TRIUNFO DO XINGU GROUPED REDD+ PROJECT VALIDATION REPORT

Document Prepared by Earthood Services Limited

Project Title	Triunfo do Xingu Grouped REDD+ Project
Version	1.4
Report ID	VCS.VAL.22.196

Report Title	Triunfo do Xingu Grouped REDD+ Project Validation Report
Client	SYSTEMICA INTELIGENCIA EM SUSTENTABILIDADE S.A.
Date of Issue	5-September-2025
Prepared By	Earthood Services Limited
Contact	B-1203, Tower B, Emaar Digital Greens, Sector 61, Gurugram, Haryana, India 122011 Tel: +91 124 4204599; Fax: +91 124 4204599 Website: www.earthood.in ; Email: operations@earthood.in
Approved by	Kaviraj Singh – Managing Director
Work carried out by	Pablo Rodríguez – Lead Auditor and Technical Expert Ana Beatriz Tukada – Technical and Local Expert

Figure 0.10 TdX Leakage Management Area

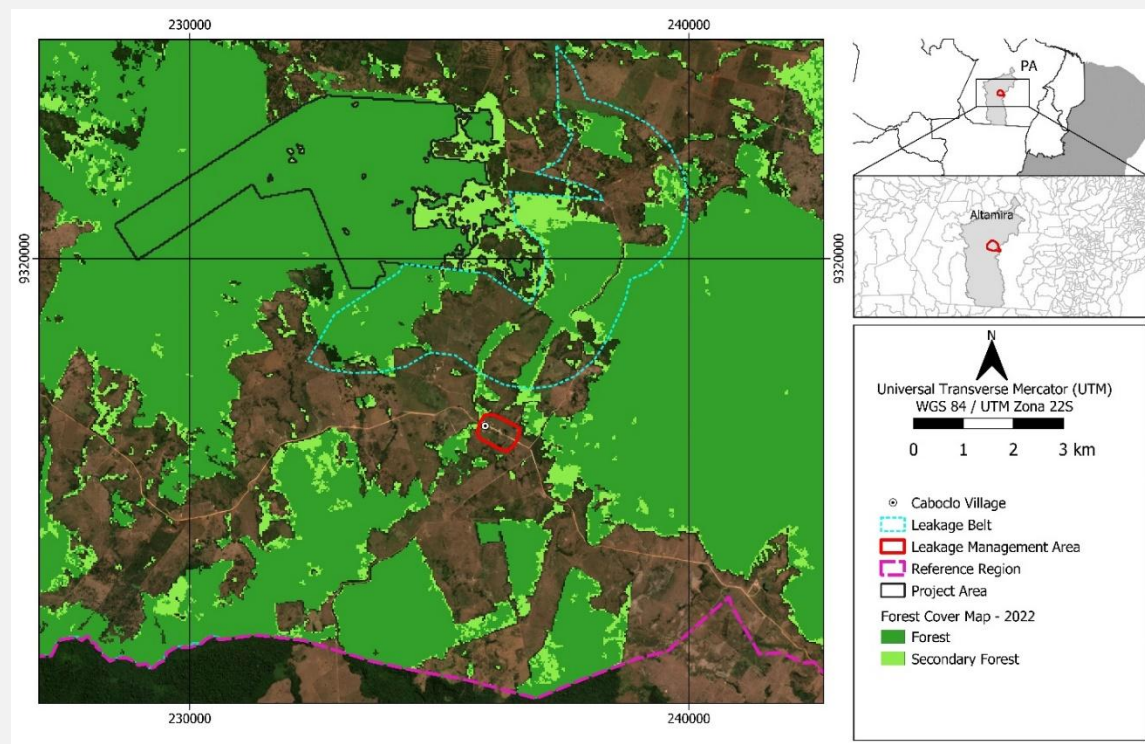
4. [...] The project proponent did not describe or define in PD v1.04 the boundaries of the leakage management area, but the monitoring plan (section 5.2, page 174) states that planned activities in leakage management areas that result in a decrease in carbon stocks will be monitored annually, when significant.		
The types of activities proposed for leakage management, given their nature, do not require the definition of leakage management areas (in contrast to the examples provided by the methodology, appearing in the excerpt quoted by the reviewer). As stated in <u>footnote 69</u> (p. 84) of the PD: “The Leakage Management (LM) area was not defined since leakage control will be carried out by the proposed activities indicated in <u>sections 1.11 and 4.3</u>”. For the same reason, we made no ex-ante estimates concerning emissions that would result from leakage prevention measures, as explained in <u>section 4.3.1</u>.

"Leakage management areas (LMA) addresses non-forest areas located outside the project boundary where the Project Proponent intends to implement activities that reduce the risk of activity displacement leakage in the project scenario and the boundary of such areas must be defined according to existing management plans or other plans related to the proposed AUD project activity (VERRA, 2012a). The LMA for this project is defined as the non-forest area encompassing Vila Caboclo's residences and infrastructure and has an area of 41.9 ha. In this location, educational activities will be implemented with the community in order to reduce the risk of leakage in the vicinity of the project area and leakage belt. The LMA boundaries are indicated in Figure 0.10, whose corresponding vector files are presented in annex (Annex: 230814_TdX_LMA.zip).

Figure 3.11 do PD v1.04:

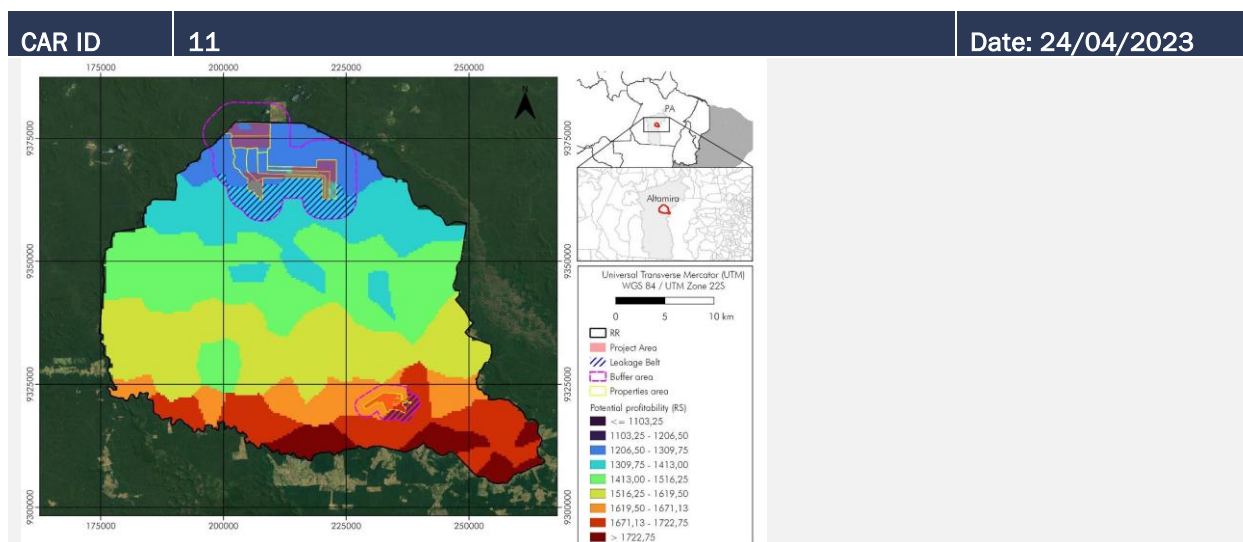
PD v1.04 section 3.3.4 states *"The Triunfo do Xingu Grouped REDD+ Project, in its first instance, is composed of seven properties. The property called Nossa Senhora Aparecida Farm to the south of the RR has a total area of 1,880.19 hectares, and the Leakage belt 1 delimited around this property was 1,931.14 hectares in a buffer of 1.7 kilometers. The other arrangement of six properties, located north of the RR, total 13,933 hectares, and the Leakage Belt 2 delimited around this property was 14,093.27 hectares in a buffer of 4.1 kilometers (Figure 3 12)."*

b) According to Figure 3.11 “Potential profitability in Reference Region, and delimited leakage belt where there are highest values to potential profitability, and their respective buffers.”, the highest values to potential profitability are allocated in the southeast region of the Reference Region, that is, in the region closest to the cities and also in the region where Caboclo Village is located.

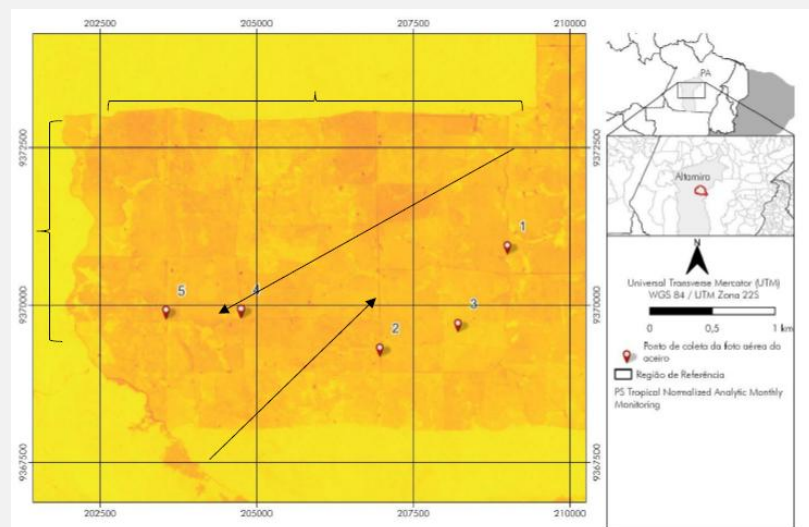
10. “Natural risk (Fire)”: the annex “221014_Firebreaks”, figures 4, 5 and 6 show the location of firebreaks on project farms.

It is not clear from Figures 5 and 6 how the fire breaks will protect the forest/project area, as they are in the middle of the property and bordering non-forested areas (in red in the figure below).
